Site Accessibility Evaluation

Americans with Disabilities Act Title II (Public Services: State and Local Government)

Environmental Building

**3255 Akers Dr
Colorado Springs, CO
80922**

Finding: 1

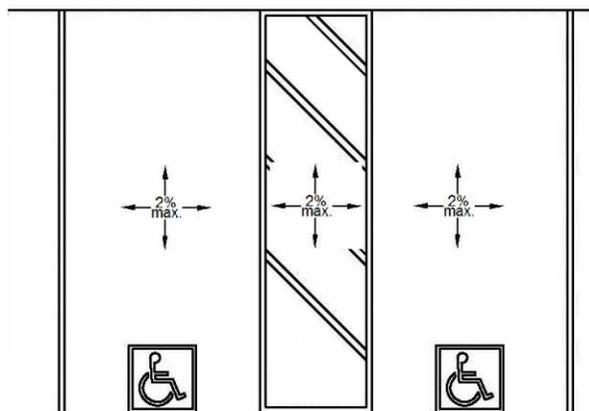
The accessible parking stall's access aisle contains a built up curb ramp which results in significant slopes greater than 2 percent.

Asphalt ramp
protruding into
parking access aisle

1. Remove protruding asphalt ramp from parking access aisle. 2. Extend existing access aisle into sidewalk and provide flare sides at no steeper than 8.33% (1:12) or add ramp adjacent to current access aisle.

Finding: 3

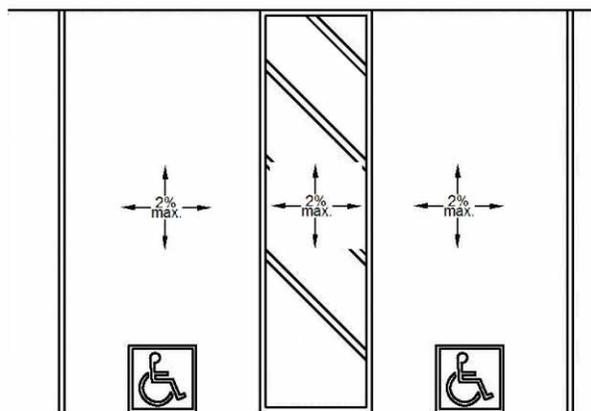
The cross slopes (narrow dimension) and/or running slopes (long dimension) of the access aisle exceeds 2%.

Running Slope @
2.71% Cross Slope @
2.79%

During next re-paving project of parking area, ensure access aisles and parking stalls do not exceed 2% running and cross slopes.

Finding: 5

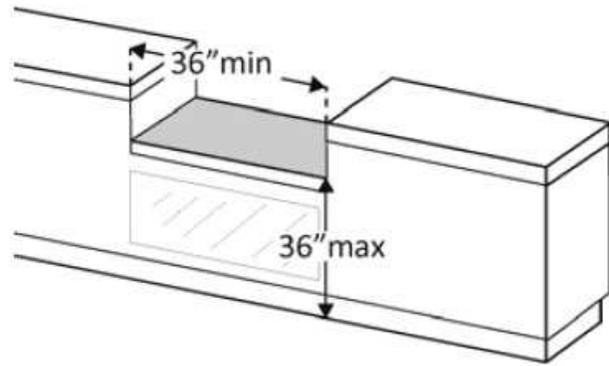
The transaction counter is too high.

Counter measured at
42.5 inches from
surface to floor.

Modify or extend existing service counter or install new counter/section that includes a section of counter surface that is 36 inches long minimum and 36 inches high maximum.

Finding: 7

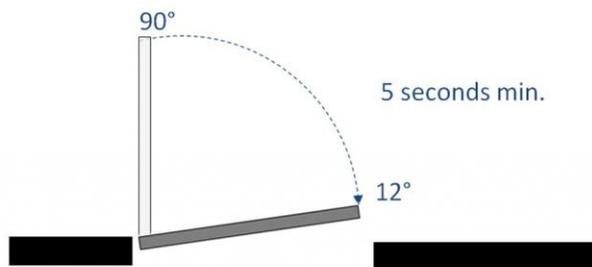
The door is equipped with a door closer and returns to a closed position too quickly.

3.5 seconds to closed position

Adjust door closer to allow a minimum of 5 seconds to move from the open position at 90 degrees to 12 degrees from the latch/locking mechanism.

Finding: 8

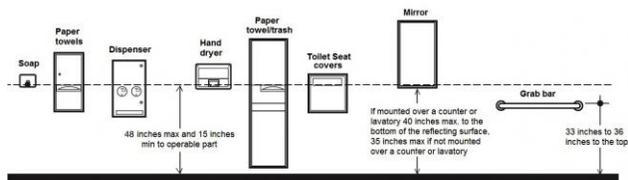
The soap dispenser's operation mechanism is too high off the floor.

49 inches above
finished floor

Lower soap dispenser 2 inches to meet compliance. 48 inches maximum height above finished floor to operable part.

Finding: 9

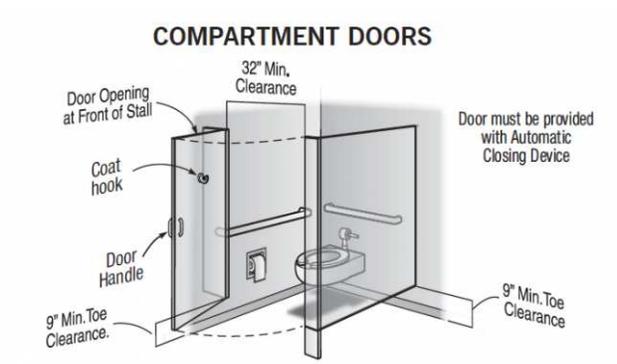
The compartment door is not self closing.

Compartment door not self-closing

Adjust or install automatic closing hinges.

Finding: 10

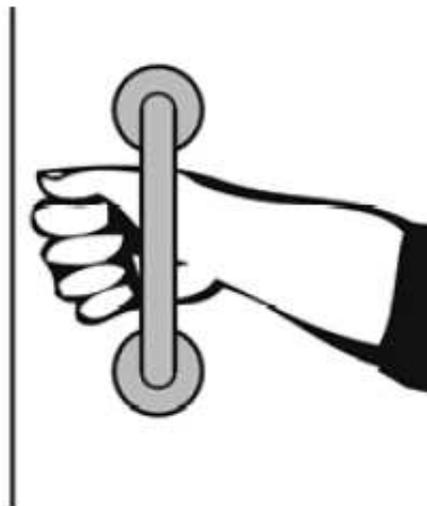
The water closet compartment door is missing a loop handle on the inside.

Missing loop handle
on inside of door

Install loop or U-shape handle on the inside of the compartment door.

Finding: 11

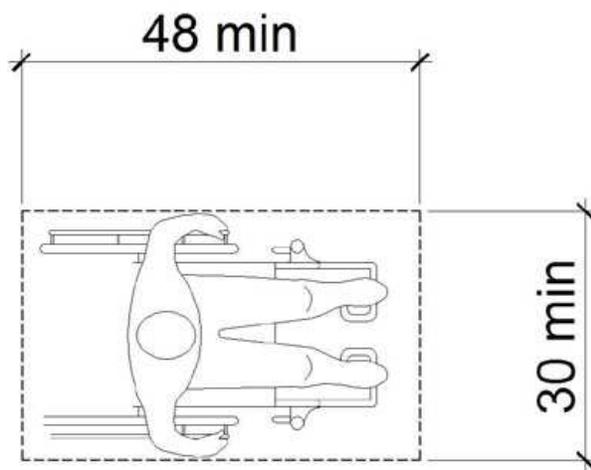
The paper towel dispenser is not accessible because there is not adequate clear floor space for either a forward or side approach.

Trash bin obstructs the required clear floor space of the lavatory and paper towel dispenser

Relocate trash bin to other area and recommend using smaller size trash bin.

Finding: 14

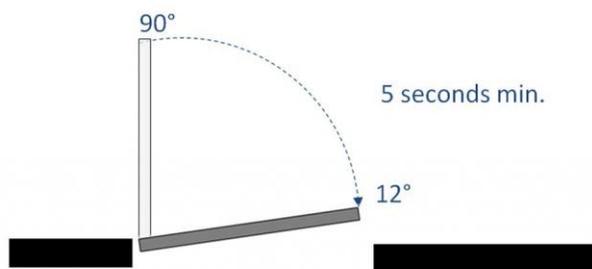
The door is equipped with a door closer and returns to a closed position too quickly.

4.5 seconds to closed position

Adjust door closer to allow a minimum of 5 seconds to move from the open position at 90 degrees to 12 degrees from the latch/locking mechanism.

Finding: 15

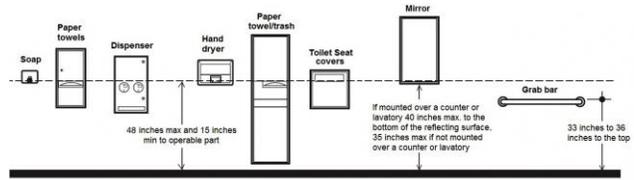
The soap dispenser's operation mechanism is too high off the floor.

48.5 inches above
finished floor

Lower soap dispenser 2 inches to meet compliance. 48 inches maximum height above finished floor to operable part (push button).

Finding: 16

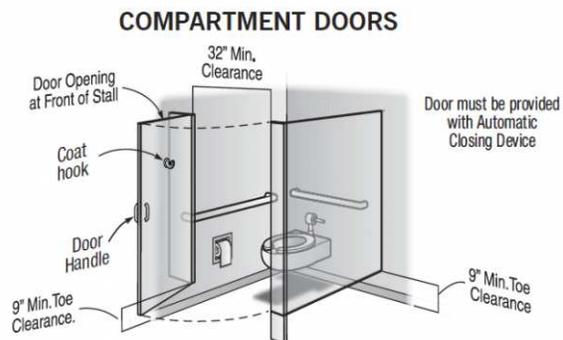
The compartment door is not self closing.

Compartment door not self-closing

Adjust or install automatic closing hinges.

Finding: 18

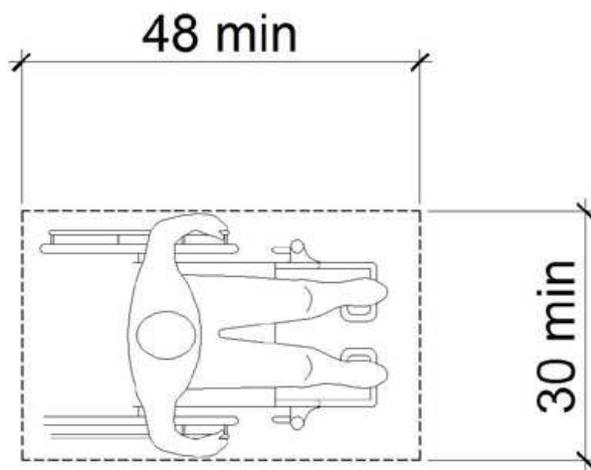
The paper towel dispenser and sink are not accessible because there is not adequate clear floor space for either a forward or side approach for either element.

Trash bin obstructs the required clear floor space of the lavatory and paper towel dispenser

Relocate trash bin to other area and recommend using smaller size trash bin.

Finding: 20

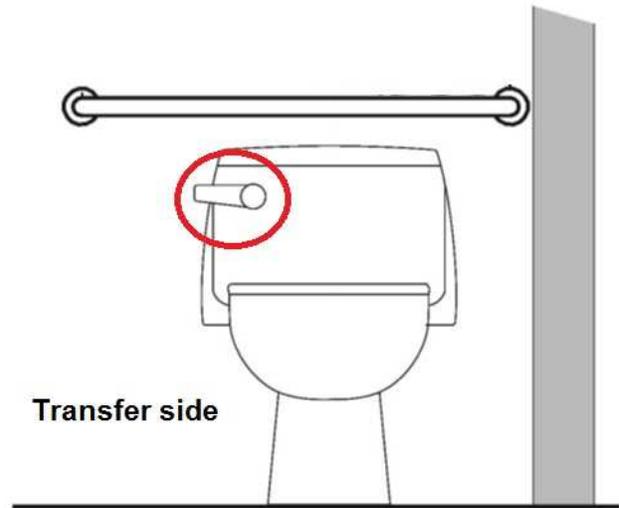
The flush handle is located on the wrong side of the toilet.

Flush handle located
on wall side

Replace toilet water tank with one that has flush handle on the opposite side (open side of toilet area).

Finding: 21

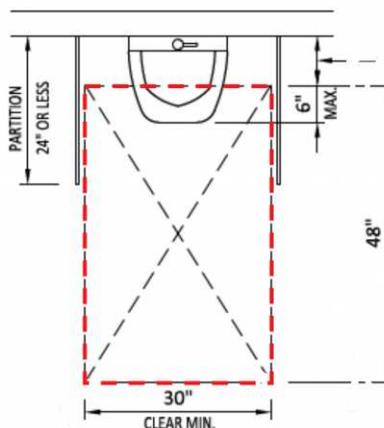
The urinal is located in an area that does not provide the required clear floor space for a front approach.

29.5 inches in width

Re-adjust surrounding partitions to provide the minimum width clearance of 30 inches.

Finding: 22

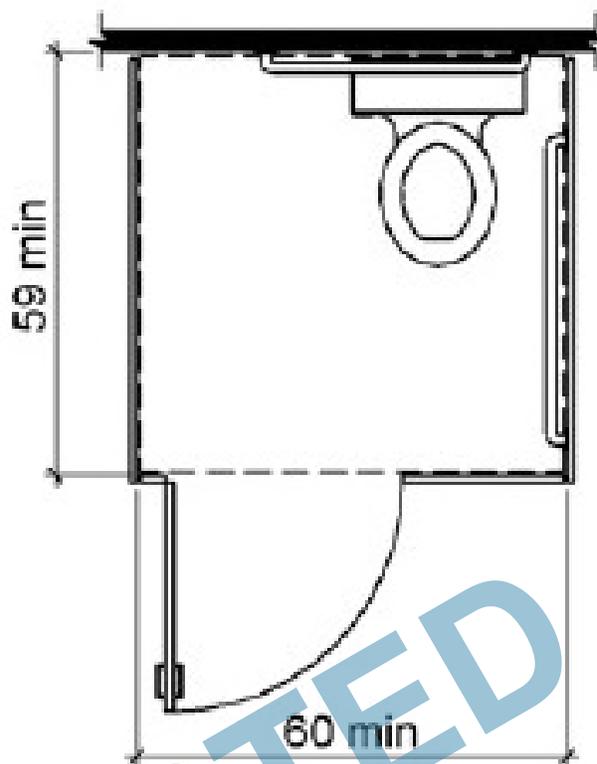
The clear floor space at the toilet is noncompliant.

Toilet compartment
depth at 56 inches

Reverse door swing to provide the minimum clear floor space of 59 inches in depth.

Finding: 23

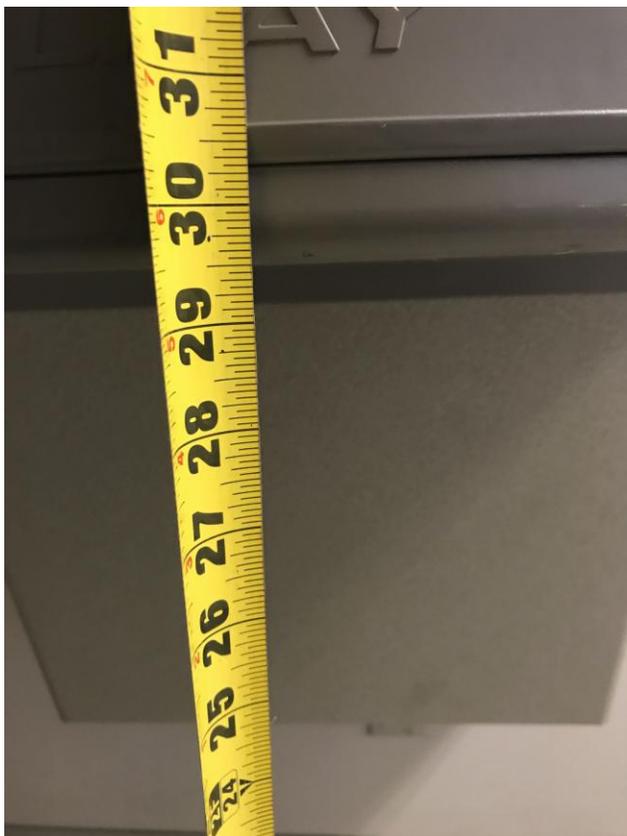
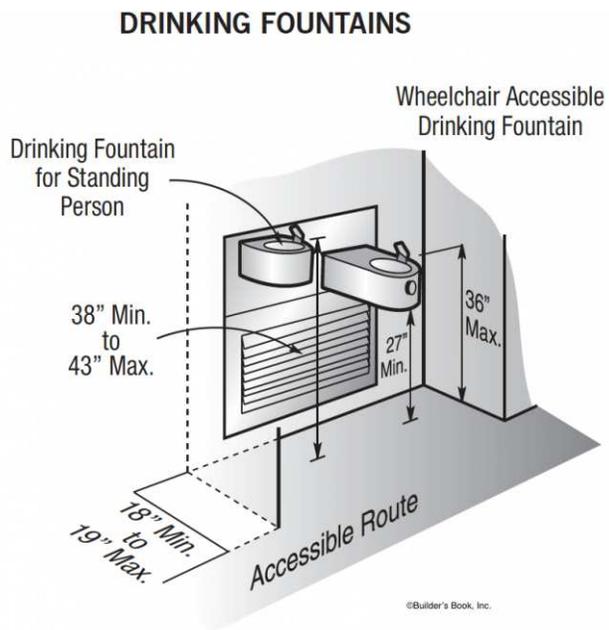
The drinking fountain is not accessible.

Drinking fountain protrudes into circulation pathway and not cane detectable

Adjust drinking fountain height to provide exactly 27 inches of clearance or install wing walls, planter or permanent fixture next to drinking fountain in order to make it cane detectable.

Also, adjust spout/water pressure to provide a flow of water 4 inches high minimum.
